Bulletin No. 2002-18

## Paint Wear

MST9205BF, MST9235BF

0029€

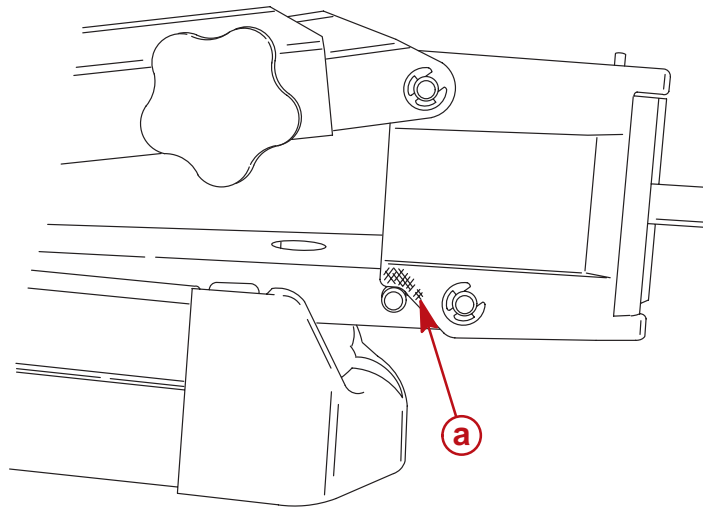
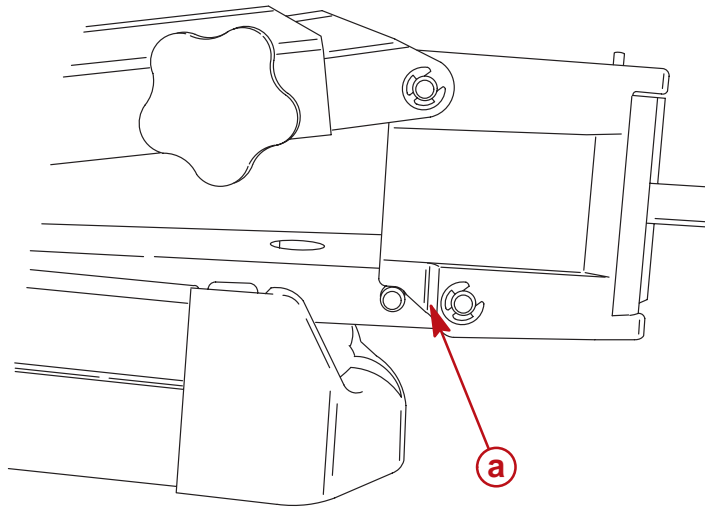
If a 20.5 or 23.5 Gator Breakaway Bracket mount is in the stow position, the bolt head (MRK02503) will rub paint off of the bracket.

**a** - Paint wear

Replace with bracket of the new design.

**a** - Newly designed part

Qty: 1      MRK01108 (Black)      MRK01109 (White)
